Proposed Minor Relaxation of Building Height Restriction for Permitted Industrial Use cum Public Vehicle Park
Fanling Sheung Shui Town Lot 245, On Kui Street, Fanling
(Section 16 Planning Application No. A/FSS/306)

- Further Information No. 3 -

Our Ref: S3187/FSSTL245/26/006Lg

CONSOLIDATED SUPPORTING PLANNING STATEMENT

Figure 3.1 Indicative Sections of the Approved GBP Scheme

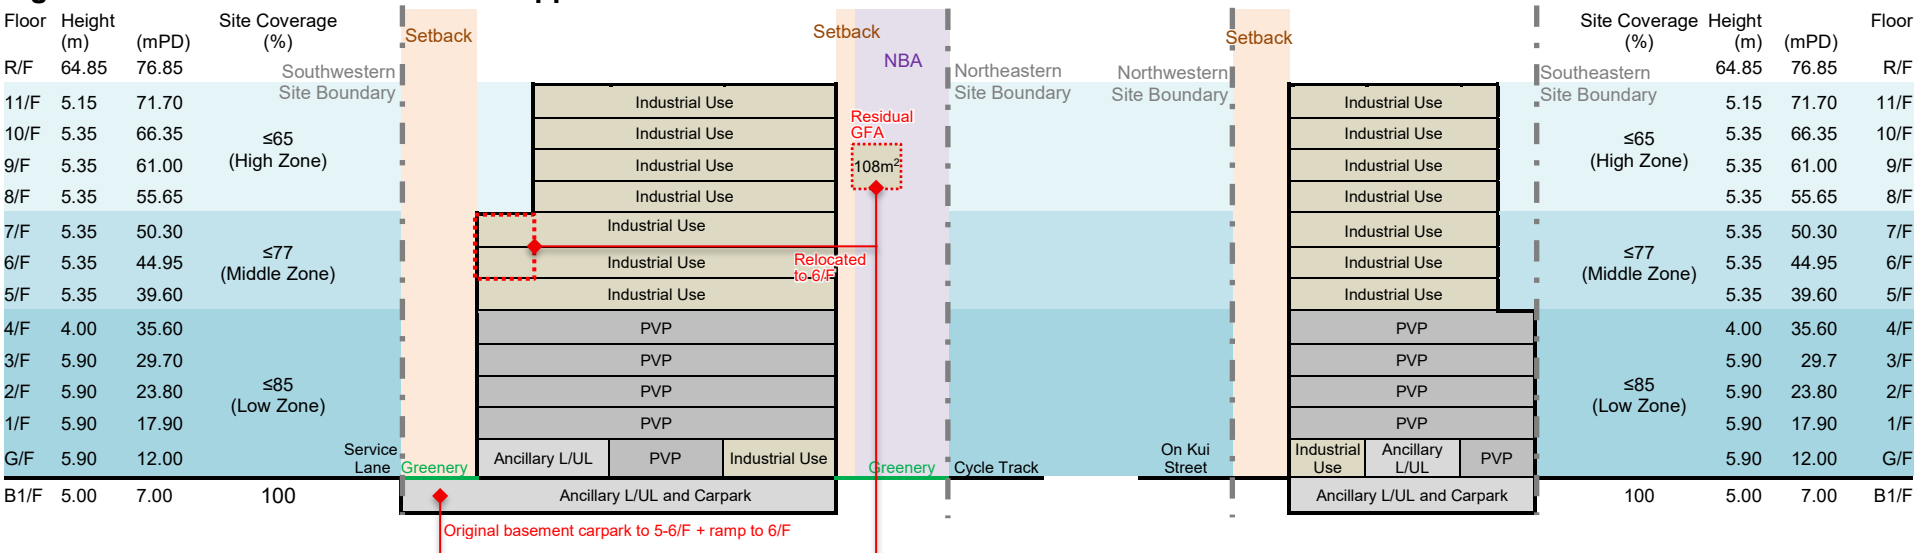
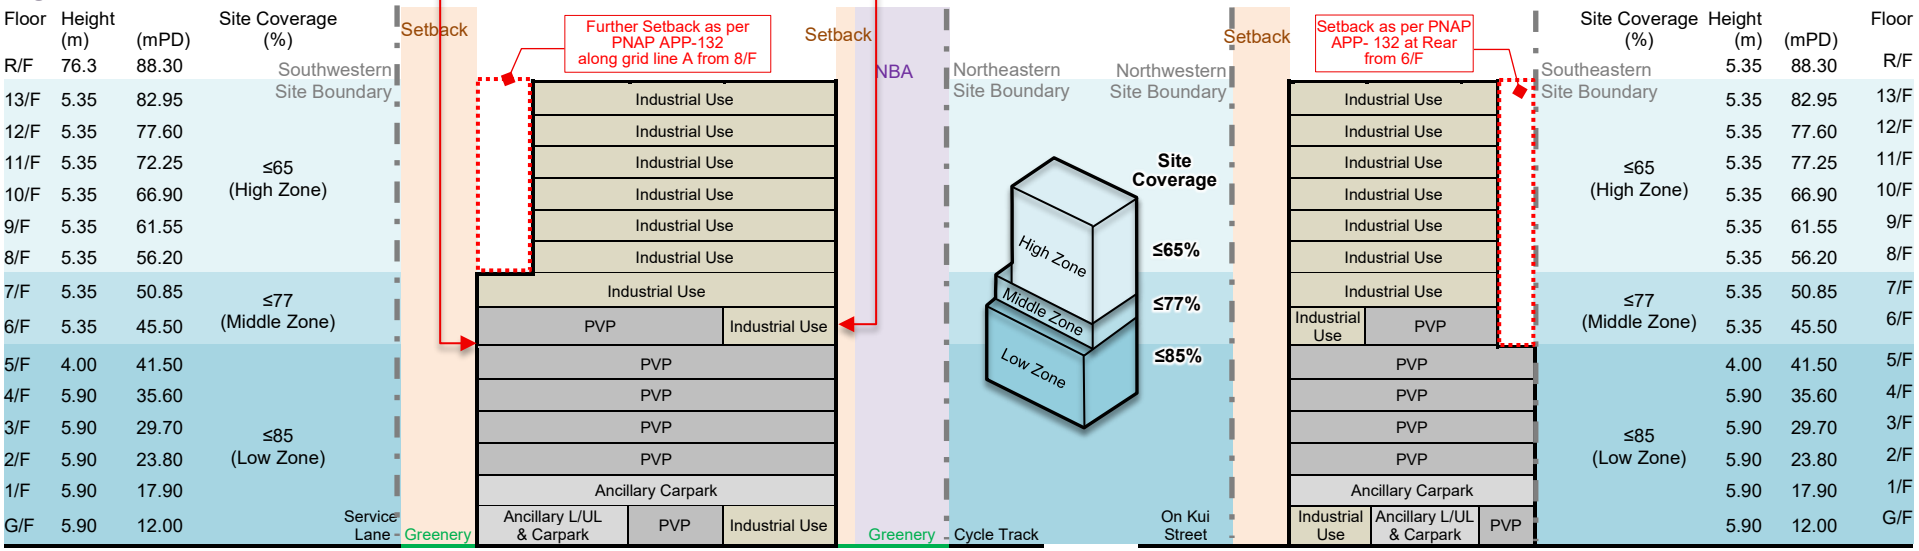
1.3	Table 3.1: It appears that the information for remarks (1) and (2) is missing. Please clarify;	Table 3.1 of the SPS has been updated.
1.4	Figures 3.1 and 3.2: According to p.8 of the Application Form and Schematic Architectural Drawings, industrial use will be provided on the G/F, whereas it is not shown in Figures 3.1 and 3.2. Please clarify;	Figures 3.1 and 3.2 of the SPS have been updated.

1.5	Figures 3.1 and 3.2: Please indicate the cycle track and service lane in Figures 3.1 and 3.2;	Figures 3.1 and 3.2 of the SPS have been updated.
1.6	Figure 3.1: According to paragraph 3.2.2 of the planning statement and the basement floor plan enclosed in the Tree Preservation and Removal Proposal, the basement floor under the approved GBP Scheme almost fully occupied the site, except for the area designated as non-building area (NBA). However, according to Figure 3.1, it appears that the NBA is still occupied by ancillary L/UL and carpark areas. Please clarify;	Figure 3.1 of the SPS has been revised.
